# Access Compliance Report

## Public Rights-of-Way

Intersection ID: 3651	Main Street: CHIPSTONE_RD	Cross Street: FOUNTAINGROVE_DR	Location:	S
ADA ID: E9E5A8B9A684	Ramp Type: Perp	Initial Pass/Fail: Fail	Overall Compliance: No	Severity Score: 37.5
Codes/Mitigation Info/Possible Solution		Field Measurements/Component Compliance

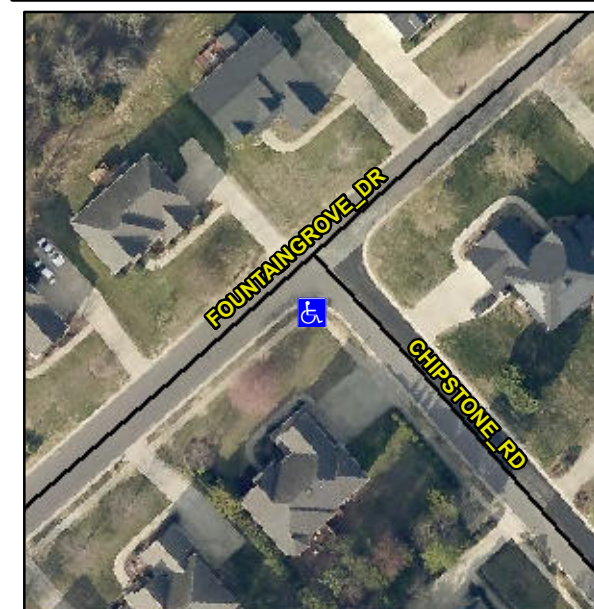
**Not Found, R304.2.2, R304.5.3**

Compliance	Description	Data	Compliance	Description	Data
N/A	Ramp Length (in)	50.0	No	Ramp Slope (%)	9.1
Yes	Ramp Width (in)	96.0	No	Ramp XSlope (%)	9.4
N/A	Flare Type LT	N/A	N/A	Flare Type RT	N/A
N/A	Flare Slope LT (%)	N/A	N/A	Flare Slope RT (%)	N/A
N/A	Flare Traversable LT?	N/A	N/A	Flare Traversable RT?	N/A
N/A	Landing Length (in)	N/A	N/A	DWS Provided?	N/A
N/A	Landing Width (in)	N/A	N/A	DWS Contrast?	N/A
N/A	Landing Slope (%)	N/A	N/A	DWS Length (in)	N/A
N/A	Landing X Slope (%)	N/A	N/A	DWS Full Width?	N/A
N/A	Landing Curb? (Y/N)	N/A	N/A	DWS Offset (in)	N/A
N/A	Shared Landing?	N/A			
N/A	Gutter Ponding?	N/A	N/A	Gutter Slope (%)	N/A
N/A	Gutter Lip Ht (in)	N/A	N/A	Gutter X Slope (%)	N/A
N/A	Painted X Walk1?	No	N/A	Painted X Walk2?	N/A
	X Walk 1 Direction	To N		X Walk 2 Direction	N/A
N/A	X Walk 1 Width (in)	N/A	N/A	X Walk 2 Width (in)	N/A
	X Walk 1 Slope (%)	1.8		X Walk 2 Slope (%)	N/A
	X Walk 1 X Slope (%)	5.2		X Walk 2 X Slope (%)	N/A

**Remove & Replace Entire Ramp.**
